RE: Preliminary Plan No. 11984260A

2 Bethesda Metro Center

Site Plan Amendment 11984260A & 81989060E

Fire Access - Response to Questions

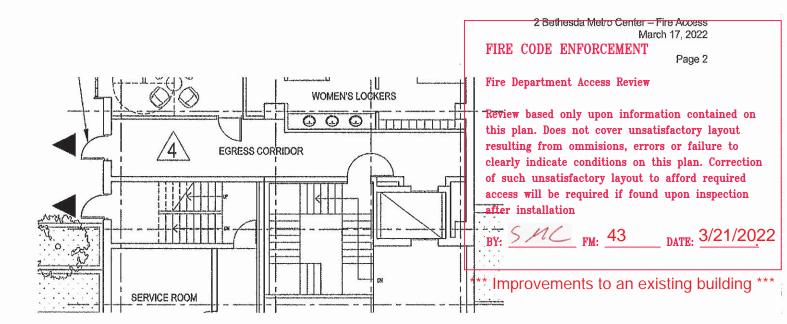
There is an existing elevator within the building, which currently stops at (3) levels of the project, the Parking Level, the Mezzanine Level and the Plaza Level. This elevator is proposed to be extended by (1) additional level, to connect to the new Fitness Level which is proposed by the new project. One important aspect of the design of the project is a new "Egress Corridor" which directly connects the elevator to the exterior of building through a public corridor. Currently, this elevator only access the interior of the tenant space, so at any time outside of business hours, this elevator is not usable by emergency first responders. The new proposal improves this situation by allowing 24/7 access from the fire department to the Upper Levels of the project, as well as the (2) spaces within the project. Please see a plan of the proposed Egress Corridor below, for reference, from the Architectural Plaza Level Proposed Floor Plan, sheet A213, dated 9/10/2021.

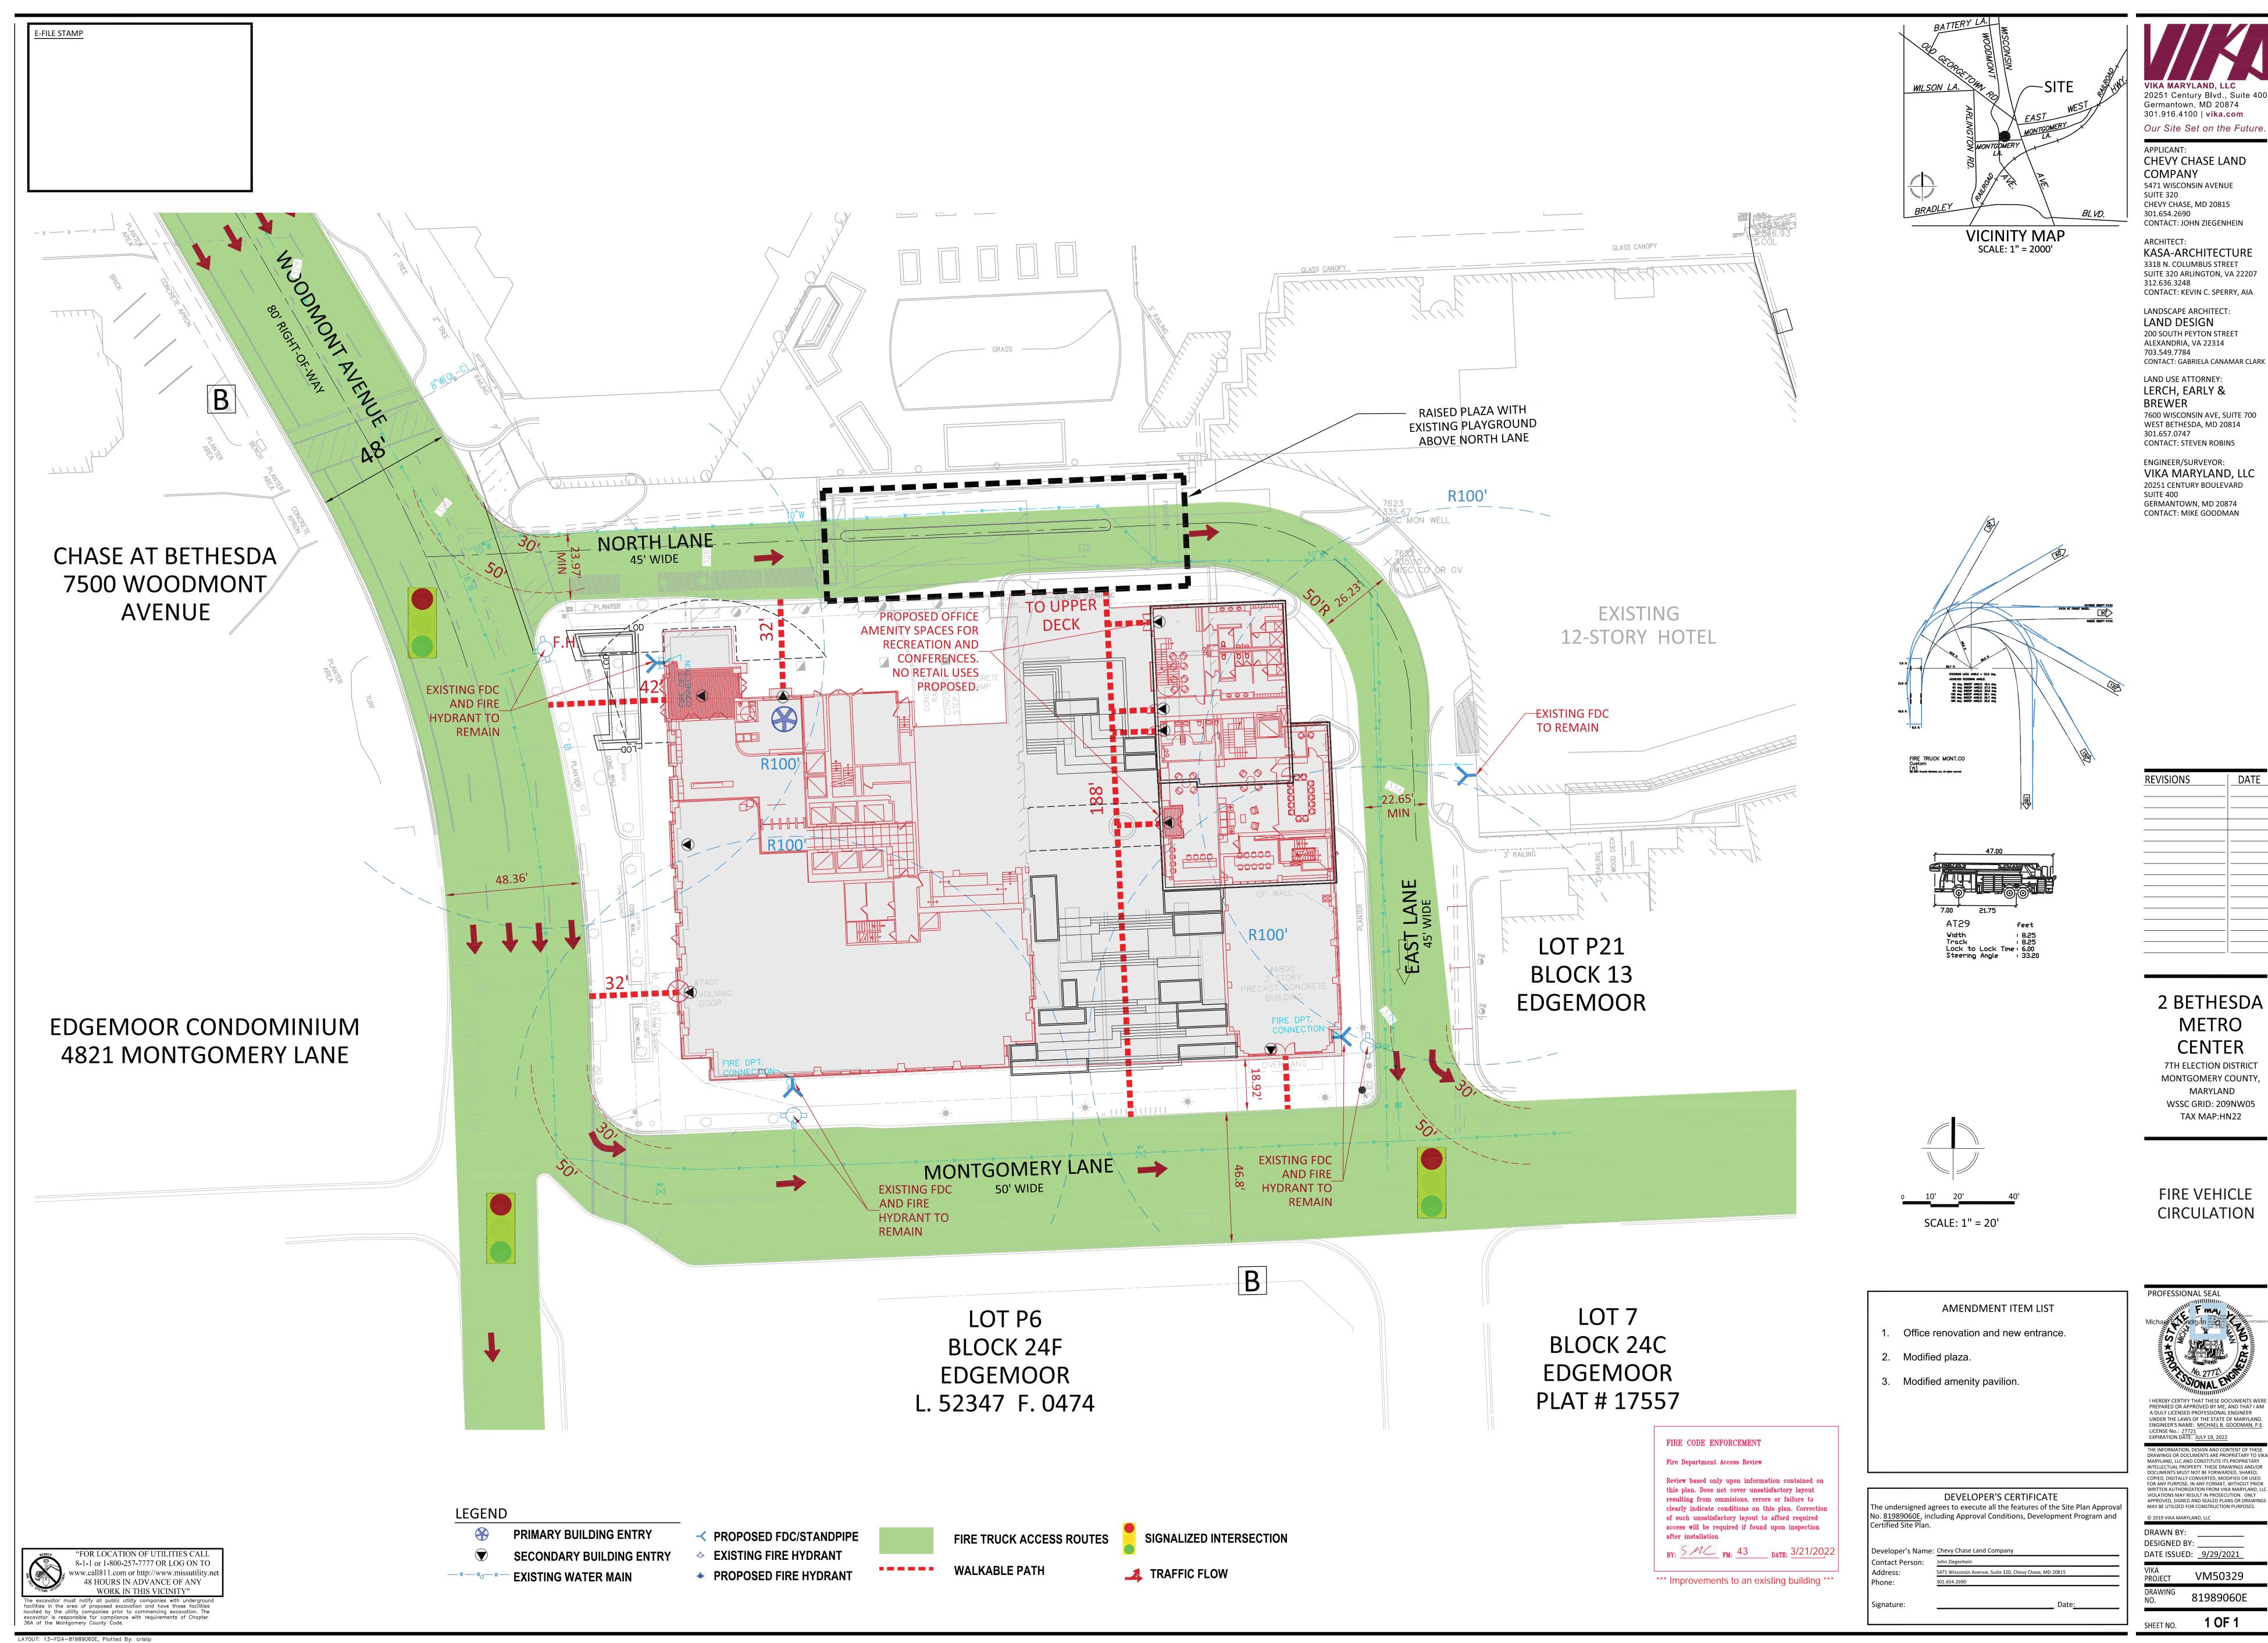
The existing building current has three entrances into the upper two tiers of the building, with no communication between the two levels. The new proposal increases the entrances of this building from three to four, and introduces full communication between the upper two levels of the structure. There are two new entrances shown on the Western façade at the upper-most level, both of which are closer to the fire access lane than the existing building entrance. This should reduce the distance from the fire access lane to the furthest corners of the spaces. The four (4) proposed entrances are highlighted on the Fire Vehicle Circulation plan, Drawing No. 81989060E, dated 9/29/2021, by VIKA.
